**BEFORE THE BOARD OF PATENT APPEALS  
AND INTERFERENCES**

Application Number: 09/872,604  
Filing Date: June 01, 2001  
Appellant(s): CALLIES ET AL.

**EXAMINER'S ANSWER**

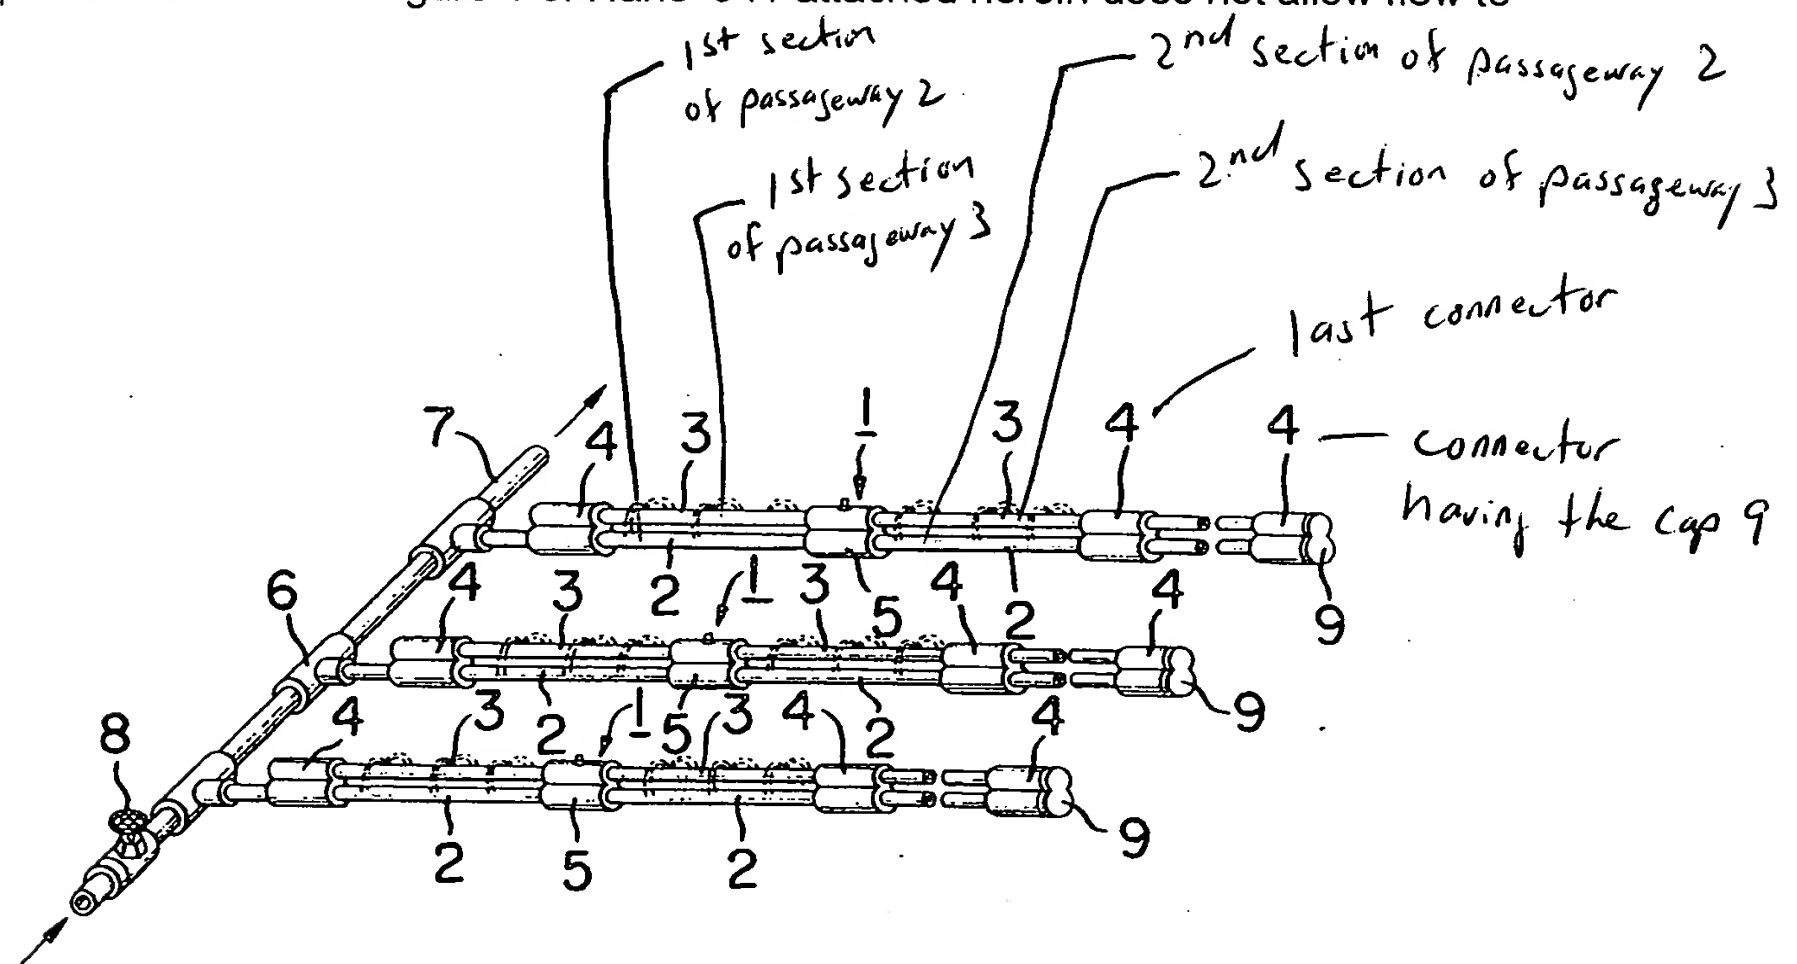
Appellant argues that claims 1, 3-9, and 14 are not anticipated by Hane (4,162,041). In the apparatus of Hane, water from main supply line 7 flows into first fluid passageways 2 and from each passageway 2 into second fluid passageways comprising hole 15 and pipe sections 3 (also considered as passages) via a fluid supply line 18 of connector 5 as seen in Figure 5. The examiner agrees that the first sockets 4 do not permit water flow from one sub-pipe segment 3 to the next segment 3, however, the second sockets 5 do permit such a flow via openings 13 in the sockets 5. As water from main supply 7 flows along one of the passageways 2, the water flows into the corresponding pipe (passageway) 3 via a supply line 18 connected to opening 13 of the connector 5 and proceeds to the second downstream end of pipe 3. The first section of pipe 3 as seen in the Figure 1 of Hane '041 attached herein does not allow flow to

proceed to the second downstream end, however, the second section of pipe 3 does permit the fluid to flow to the second downstream end through 18 as stated previously. Thus, the combination of the first section of pipe 3, the connector 5, and the second section of pipe 3 permits fluid flow from the first upstream end to the second downstream end. Since Applicant's claim 1 recites "each passageway permitting fluid flow from the first upstream end to the second downstream end", the device of Hane meets this claim language since passageway sections of passageway 2 along with connector 5 permits fluid to flow from the first upstream end to the second downstream end as does the combination of the first and second sections of passageway 3 along with the connector 5.

Hane also shows a cap 9 attached to a socket 4 as seen in Figure 1 of Hane '041 attached herein. The apparatus of Hane as seen in Figure 1 alternates a connector 4, a connector 5, and another connector 4. If the last connector 4 (the one farthest from the main supply 7) is capped with cap 9, then the water flows from the upstream end (end near the main supply 7) to a second downstream end which has the capped connector. The connector 4 having the cap as seen in Figure 1 is actually not a part of the apparatus of Hane since it is only there to teach that the last connector of the apparatus of Hane would have a cap 9. Thus, for a relatively shorter field to be irrigated, one having ordinary skill in the art would recognize that there may not be a requirement for additional connectors 5 and that the last connector 4 could be capped with a cap 9. Since the Applicant is claiming "fluid passageways", the sections of 3 in conjunction with holes 15 of the connectors 5 form a "fluid passageway" that permits flow from the

Therefore, the apparatus of Hane comprises more than one fluid passageway throughout its length-one formed by the sections of passageway 2 which are fluidly connected to each other via connector 5 and a second passageway formed by the combination of the sections of passageway 3 along with the hole 15 of connector 5 as stated above.

Regarding Applicant's argument that Hane does not show a second fluid supply separate from the first or main supply line, the examiner respectfully disagrees because water from pipes 2 flows into pipes 3 via flow passage 18 of connector 5 and thus passage 18 is a second fluid supply line which supplies water to pipes 3. The Applicant has not claimed further limitations of the "second fluid supply line" itself. The passage 18 of connector 5 can also be considered as an "alternate supply."

Regarding the 35 USC 103 rejections of claims 15 and 22, the branch sockets 6 of Hane are considered as adapters and since Hane also shows a regulator valve 8, one having ordinary skill in the art would know that if the valve 8 was placed in the first adapter of the water flow direction, the valve 8 would still properly regulate water flow to the apparatus of Hane.
